COMMENTS/IDEA MAP Butler Trail at Southeast Shore: Master Plan and Improvement Strategy Prepared by McCann Adams Studio for The Trail Foundation and the City of Austin Updated 2.11.2014 See www.austintexas.gov/seshore

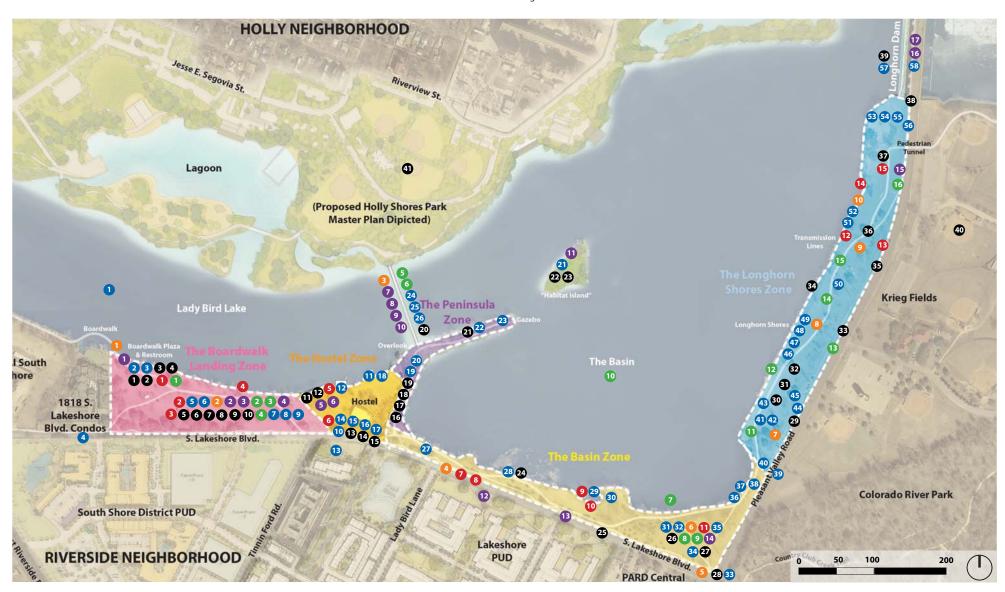
Working Group Meeting Monday, June 10, 2013	Adjacent Developments Friday, August 16, 2013	City of Austin Thursday, August 19, 2013	Community Workshop #1 Thursday, October 17, 2013	On-Trail Outreach Saturday, January 18, 2014	Community Workshop #2 Wednesday, January 29, 2014
Park-Wide	Preserve natural character of park. Dogs are big issue. Park is too small for off-leash dog area. The park's shallowness in depth is challenping. Don't put parking on parkland: make use of street parking to serve park. Colorado River Park's existing parking lots could serve the Southeast Shore. Create places to experience shoreline, views, i.e., overdocks. Manage invasive plants. Provide places where people can contact water. Enhance wildlife habitat. Create ind-friendly places that punctuate/ penetrate ripatian ecceystem (docks, shelters, etc.), where bird-viewing is possible, places without through-traffic. Trail should not be lit, so natural character is kept. Add water fourthans throughout the park.	 New residents with dogs will primarily use on-property open space for dog relief. If an off-leash dog area is proposed, fence it. New residents are interested in accessing health, fitness, yogs and entertainment in park. Increase number of water fountains and restrooms in park. Safety, security and lighting should be the priorities. Build docks for kayaks, paddleboards and other on-water activities. Property managers will host volunteer days for trash pick-up, invasives removal, or even crape myrite pruning. Keep Austin Beautiful (KAB) could facilitate South Shore District volunteer maintenance activities. 	 No new structures should be allowed within 100 feet of shoreline. Minimize paved surfaces in park and create cycle tracks along Pleasant Valley Rd, and Lakeshore Brvd. Maintain and repair riparian zone. Remove invasive species throughout park. Use The Wildflower Center's drought resistant Habiturf for lawn areas. 	 Make sure that Park Rangers patrol the area for safety. Provide many benches and trash containers along the Trail. Install dog waste stations. Keep the shoreline natural. Make the park childr and family-friendly. Keep the park pristine. Allow for Informal use of areas instead of creating spaces for formalized activities. 	 Provide more parking, Keep the trail flat, Make the trail safer. Have lots of trees. Provide different kinds of activities every half mile, i.e. ramps, exercise blocks, pull up bars. Provide water stations- with fourntains and bottle spigots every mile. Provide more pet bags. Create art installations that also function as workout stations. Provide more restrooms. Have fewer events. 	 Provide dog waste stations frequently throughout park. Provide trash and recycling receptacles. Don't allow paid parking meters along Lakeshore Brd, or Pleasant Valley Rd. Don't allow further commercialization or concessions in park land. Provide more pincit tables and benches. No concrete or impervious surfaces allowed on parkland. Keep park natural. No of leash dog areas permitted. Increase frequency of trash pickup in along water's edge. Maintain 25' buffer from water's edge to trail. No large events allowed in this segment of parkland.

Boardwalk Landing Zone	 Limit paved areas and create more shade. Address conflict between peds and cyclists, as The Trail serves an important transportation role. Allow recreational cycling next to shoreline. Boardwalk may or may not be open 24 hrs – consider appropriate lighting. 	 If 24-hour access to Boardwalk is implemented, provide lighting for increased safety. Create a small event space in the park for performances and pop-up events around SXSW and other festivals. 	 Continue concrete surface from Boardwalk to proposed, cycle tracks on Lakeshore Blvd. at no more than 5% slope. Re-grade open space for pick-up soccer and other informal recreation. Create small events space near boardwalk landing. Build deck structure over new stormwater outlet, and maintain access for service. 	Provide trailhead concessions, like snacks and water. Minimize food concessions due to the trash that these produce. Provide water sports rental. Provide dock or viewpoints from land. Provide more bicycle parking. Farmers market would be nice in this area. Small events space for families of slightly larger groups. No amplified music. Pre (unscheduled) activity area. No tormal fields.	 Provide more water fountains. Keep running trails separate from bike trails. Create tricks play areas. Provide exercise stations. 	Designate space for sports vs. recreational use to reduce water navigation conflicts. Do not allow more boat launches. Provide launch for personally-owned paddle boards, cance, kayak and small sail boats. Need visual clearance for exiting driveways onto Lakeshore Bivd. Protect Lower Colorado River Authority (LCRA) trees. Widen trail for shared use. Provide exercise stations for public use. Allow pop-up art installations. Press. Res.

Hostel Zone	 Reconsider creating a new trailhead near Hostel, given conflicts with hostel parking. Provide more restrooms along the Trail, as Hostel restroom is often used by trail users. 		 Remove non-functioning stormwater outlet and fix sink holes. Add trailhead functions. 	 Provide bicycle parking for concessions. Confine concessions to this zone. Do not add more concessions. Keep Hostel functioning at this location. No metered street parking – parking should be free for park users. 		 Allow light food and drink service. No space provided for off-leash dog areas. Plent more shade trees. Concessions should be located out of park. Leave hostel in park. (8) Hostel should become community rental space. Hostel should become an event rental space. Dougherty Arts Center should move to hostel site. Allow an off-leash dog area.
Peninsula Zone	 Proposed ped bridge landing to Holly Shores should be located as far from tip of peninsula as possible to preserve quiet, bird habitat. Perhaps prohibit bike access to peninsula. Implement proposed ped bridge to Holly Shores: it will help connect Hostel visitors. Proposed bridge could become a hangout space itself. Any new bridges should provide sufficient clearance for boats: "river boats, rowing boats and stand-up padde boards. "Habitat Island" is known as "Snake Island" - a popular party venue on full moons. 	 Implement the proposed ped bridge to Holly Shores. 		 Keep this zone natural. Keep this zone quiet. Clear the invasives, especially ragweed. Protect the riparian zone. Build a new pedestrian bridge by dam instead. Keep the water and trail connections limited (i.e., don't allow continuous view - and dog access - to the water). Don't allow people on the Habitat Island off the tip of the Peninsula. Provide an outdoor classroom for cancers on the Habitat Island 	 Likes the pedestrian bridge connection to Holly Shores Park Master Plan. Does not like the pedestrian bridge connection to Holly Shores Park Master Plan. 	 Allow a sculpture park. Provide public art opportunities. Keep Habitat Island preserved. Keep paninsula preserved. Like existing gazebo at end of peninsula. Like bridge connecting to Holly Shores. (6) Don't like bridge connecting to Holly Shores. (18) Need clearance for boats under bridge.

Basin Zone	 Cypress' "Paseo" will be a place where peds will cross Lakeshore Blvd.: create and designate this crossing clearly. Access is critical across Lakehore Blvd.: consider installing "Hawk" (pedestrian-activated) signals. Develop a trailnead at Lakeshore/Pleasant Valley Road intersection linking to Country Club Creek Trail, that includes parking, amenities, way-finding, etc. 	 Provide designated crosswalks and possibly pedestrian-activated crosswalk. Improve public street-lighting on Lakeshore Blvd. and Pleasant Valley Rd. Provide quiet places for yoga/Zen garden as well as cross-fit/boot camp space at intersection of Pleasant Valley Rd. and Lakeshore Blvd. 	 Provide better lighting, sidewalk and pedestrian cross-walks along Lakeshore Blvd. Propose two-way cycle tracks and parallel parking along Lakeshore Blvd. Remove debris, improve landscape and water quality near the "Cove". Create avegetated embankment into the water at the "Cove". Create landscape feature for stormwater drainage near the intersection of Lakeshore Blvd. and Pleasant Valley Rd. 	 Protect riparian zone. Connect the trails from the new developments along Lakeshore to Bulter Trail. Create a "food forest", with native trees like pecan, at the corner of Pleasant Valley and Lakeshore Blvd. Provide trail concessions like enacks and water. Make pedestrian crossing make safer and allow left turn from Lakeshore. 	 Create a protected water play area for kids. Provide an exercise station. Create something that will activate area. Create a sailing Olympic triangle. 	 No food trailers allowed. Need conversation with Watershed Protection Department about the "Cove" improvements, Like the plans for the "Hollow". Like increasing the number of native plants. Hoed barrier between park and traffic. Provide safe connection to Country Olub Creek Trail. Allow for view of lake from trail. Provide a small fishing pier to preserve landscape from being trampled. Provide a small fishing pier to preserve landscape from being trampled. Provide launch for personally owned paddle boards, cance, kayak and small sail boats. Don't allow street vendors. Like the rain garden idea. Provide safe crossing to Guerrero Park.

r Longhorn Shores Zone	 Make explicit and improved connection(s) to Colorado River Park. Austin Energy is looking at options for renovating the dam, one of which may be the construction of a tabyinth weir on top of an existing foundation located on the east side of the dam structure and removal of existing mechanical gates. Foot of Longhorn Dam (east side) is a great place for birds, but not a good place to observe birds. Colorado River Park's existing parking lots could serve the Southeast Shore. 	 Install sidewalks along Pleasant Valley Rd. Larger events should take place on Longhom Shores. Provide multiple boat launches for kayaks on north end of Longhom Shores. Consider a dog park at Longhom Shores that would address a regional need, but may be too distant for residents' daily use. 	 Include boat launch location to align with entry to Krieg Fields. Provide left turning lane for entry to both Krieg Fields and boat launch. Provide solid surface for dog entry into water to reduce shoreline erosion. Define a specific fenced-in area for dogs. 	 Keep/facilitate the fruit truck vendor. Create informal fields for pick-up games. Make picinic tables available for neighborhood use. Don't allow big festivals. Formalize edge of Pleasant Valley with parking, cycle tracks and sidewalks. Protect the riparian zone. Frovide cycle tracks from Lakeshore Bivd. to Longhorn Dam on west side of Pleasant Valley Road. Maintain new trees and landscaping. Improve/widen the existing pedestrian tunnel. Create bicycle access from Riverside Drive to Cesar Chavez Street. Build new pedestrian bridge near Longhorn Dam. 	 Create something that will activate area. Provide a boat launch. Create better defined trails near baseball fields. Provide a water station. Provide a batter top dressing on trail. Make the sidewalk going uphill to Longhorn Dam safer and wider. 	 Don't allow food trucks. Provide more shade, Plant native plants. Keep visual access to lake. Arovide pedestrian crossings across Pleasant Valley Rd. Replace wood fence with art panels. Freil needs directional signage. Doesn't want promenade structure. Doesn't want orronated structure. Doesn't want orronated structure. Doesn't want orronated structure. Doesn't want orrenated structure. Doesn't want orrenated structure. Doesn't want orrenated structure. Doesn't and the promenade structure. Doesn't and the promenade structure. Doesn't and the promenade structure. Doesn't want overlook into water. Neb og arafiti art. (2) Want an off-leash dog park. (6) Water ant off-leash dog park. (6) Provide lighting for pedestrian underpass. Like pedestrian bridge. Maintain four-lane road layout on Pleasant Valley Rd. at Longhorn Dam.

Other				 Reduce glare created from Krieg Fields lighting. Reduce glare from Austin Energy sports lights.
